TECHNICAL SERVICE BULLETIN

Bulletin Nbr: 210-2486 utg.2

Saab 9-5 M98- with engine alternative B205 and B235

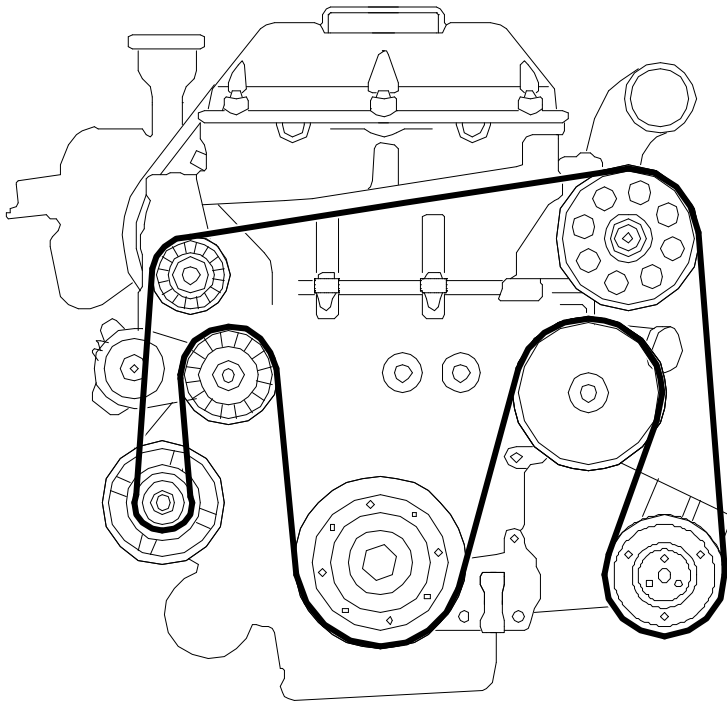
The centre tensioning roller of the belt circuit has been removed on cars from and including Vehicle Identification Number 43505872. This means that the belt for cars from and including the above Vehicle Identification Number is shorter than the old one.

The old (longer) belt that was previously discontinued is now back in stock again, and this belt must be used for belt replacement on cars up to and including Vehicle Identification Number 43505871.

E121R172

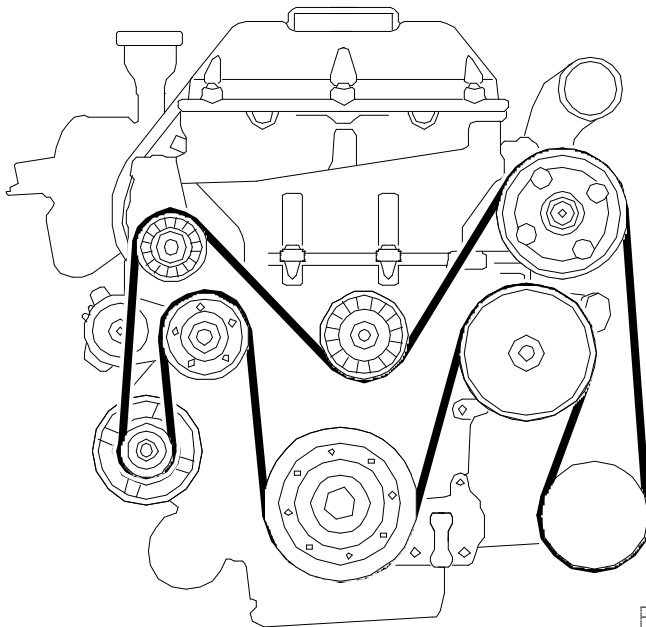
For belt replacement, see the illustration for the new belt circuit routing.

New version:

48 99 548 (CA: 30568609) Belt (up to and including Vehicle Identification Number 43505871)
